**Annex to Yorkshire Water
Statement of Response for
WRMP24**

April 2024

Further information required to support a decision on the Water Resources Management Plan

Figure 1-Normal and drought reservoir control lines and modelled Yorkshire Regional group stocks

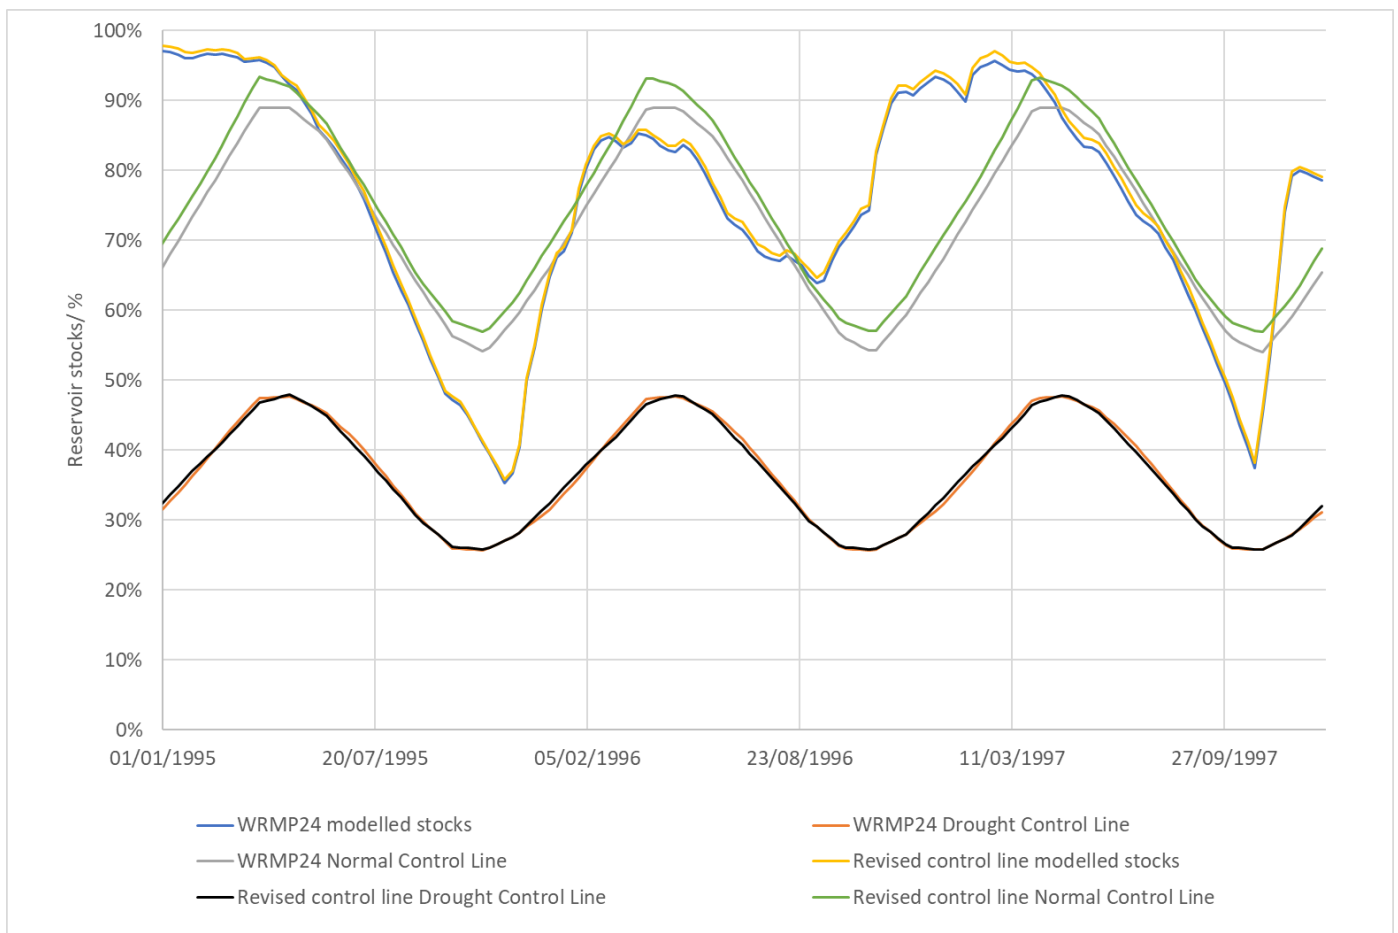
The company needs to finalise the assessment of the impact of 2022 drought and should specify how it is bringing the lessons learnt into its WRMP. In doing so, Yorkshire Water needs to address all the bullet points raised by the Environment Agency in its representation of the company's WRMP. The company will also need to update control curves and groundwater yields in the revised submission.

We have also reviewed groundwater deployable outputs, and the yield and control lines of reservoir sources based on our 2022 inflows, including our emergency storage assumptions. These result in a very slight change to our control lines, but no changes to our emergency storage assumptions. Our emergency storage is the larger of 20 days' supply at yield, or 12.5% of reservoir stocks, and in all cases the 12.5% is larger, so this has resulted in no change.

Figure 1 shows the normal and drought reservoir control lines used for the WRMP24 supply modelling, and the updated control lines using inflows including the 2022 drought. It shows that the drought control lines are almost identical, but that the updated normal control lines are a little higher than those used for the WRMP24 modelling. This would result in the use of reservoirs reducing sooner and river use increasing sooner than in the previous modelling. The modelled reservoir stocks are almost the same in both circumstances.

These analyses show that although there are slight differences between the control lines when the 2022 drought is included in the period of record used to generate the control lines, there is no substantive change to the supply forecast, and we have not repeated all supply forecasts using the revised control lines.

Figure 3- PCC WRMP glidepath to 2035 using normal year in-year PCC when compared to the glidepath's submitted across the industry.

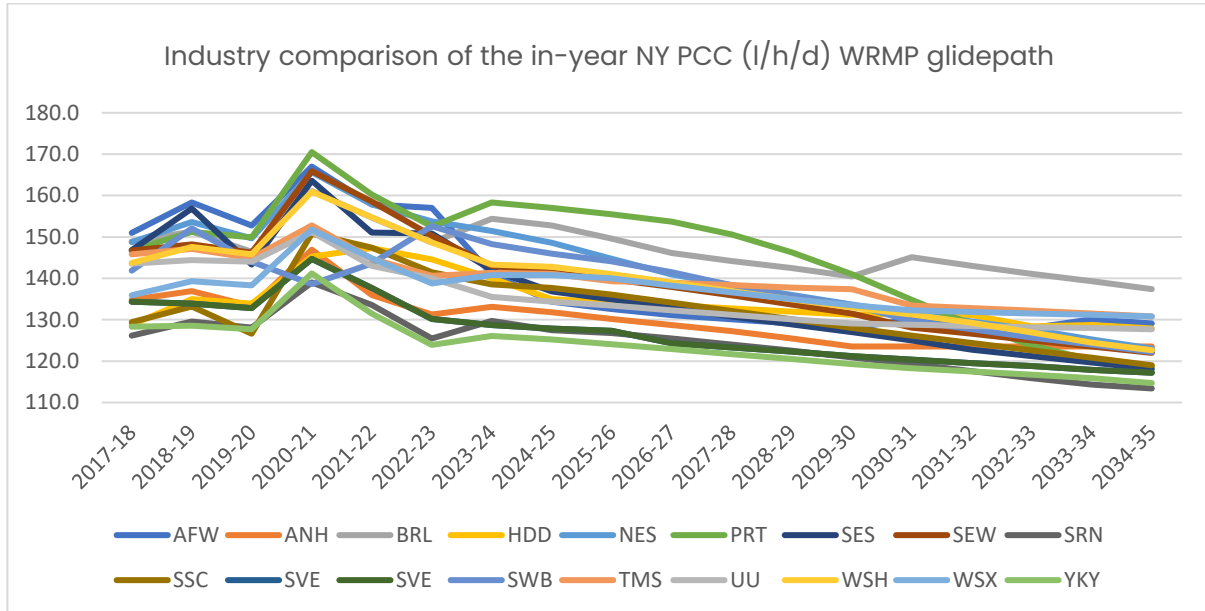
Ofwat do not consider that Yorkshire Water's PCC ambitions to 2029/30 are sufficient as the company has failed to deliver against commitments in AMP7, has a lower commitment to reducing PCC compared to that set out in WRMP19 and that the reductions demonstrated are comparatively low compared to the wider industry. Ofwat also highlight that additional modelling is required to set out the glidepath for demand reduction and therefore the AMP8 ambition may change.

Yorkshire Water's modelling should be completed before the final plan is published. This should include any glidepaths considered and a commitment to improving PCC ambition.

- We have reviewed the WRMP24 and PR24 tables relating to PCC. The analysis of these tables confirms that Yorkshire Water both using "in-year" and "3-year average" metrics has set targets to achieve the lowest or second lowest PCC in the sector respectively, alongside Southern Water (reference Figure 3 below).
- This target for frontier performance continues into AMP9, including surpassing the interim target of 122l/h/d in 2038 by 7.6l/h/d according to our in-year dry year PCC forecast.
- Our longer-term plan surpasses the 110l/h/d target in 2050 by 4.5l/h/d according to our in-year dry year PCC forecast (reference Figure 4 below).

The data below taken from table OUT1 of the PR24 submission supports the position that Yorkshire Water remains frontier in the sector in terms of performance over the next decade, whilst materially reducing PCC through a blended strategy of interventions.

Figure 5- Distribution input (DI) comparing the revised draft WRMP DI and the new WRMP DI taking into account updated NAV exports.

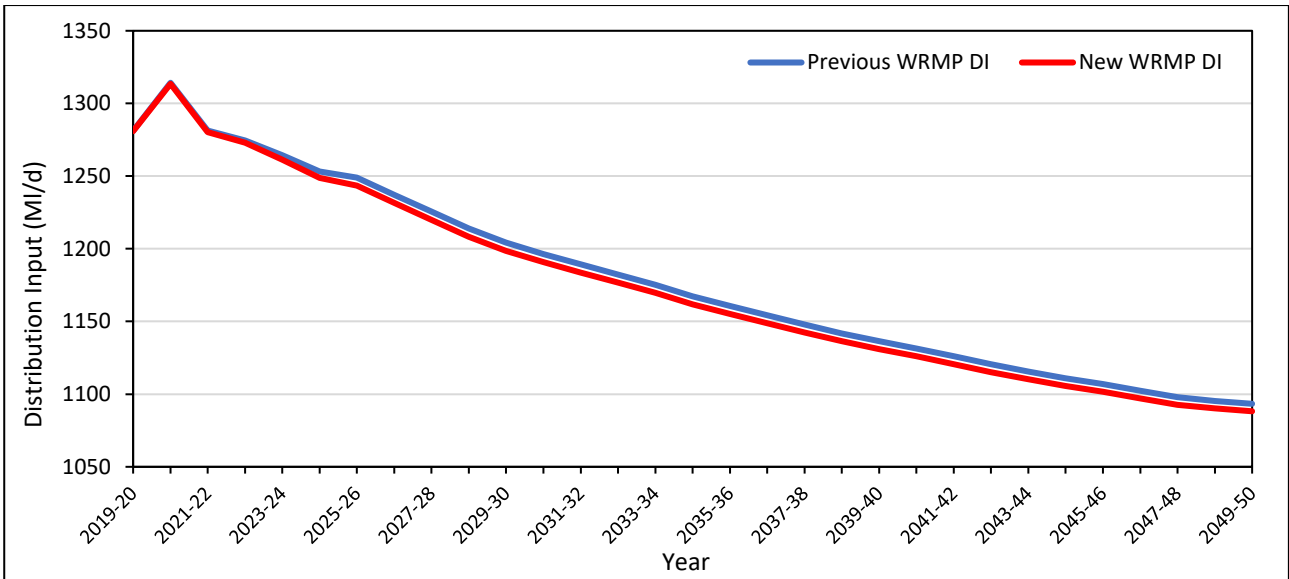
New Appointments and Variations (NAVS) are required to produce a statutory WRMP. This means that when ensuring alignment with regional and neighbouring water company plans incumbents should ensure alignment with the NAV plans. This means the transfers to each NAV should be described in the plan and contractual volumes should be set out in the planning tables. Yorkshire Water should also ensure properties and populations served by NAVS are not included within the forecasts in the company plan going forward.

This is to prevent double counting of demand components and also overstating supply. The company should ensure the volumes transferred to NAVS are recorded in the planning tables. The company should work with the NAV companies to ensure alignment of assumptions e.g., number of sites, population, property, and contractual volumes. We do not expect incumbents to forecast beyond the appointed sites set out in the NAV WRMPs i.e., new sites will be awarded but the incumbent will not know when and to which NAV. The company should use the WRMP cycle to update the figures and adjust forecasts accordingly.

The overall impact on our supply-demand balance of the changes to include the latest NAV WRMP values is modest and does not change the planned investment decisions or our performance commitment glidepaths (that is, per capita consumption (PCC), leakage, and non-household demand). Our final planning distribution input (DI) at company level is impacted by an average decrease of 4.95Ml/d, with the majority of the change impacting the Grid Water Resource Zone. The net average impact on the water available for use (WAFU) is a decrease of 5.97 Ml/d, this has resulted in a net average impact

to our supply-demand balance of 1.02 MI/d over the forecasting period, as shown in the figures below.
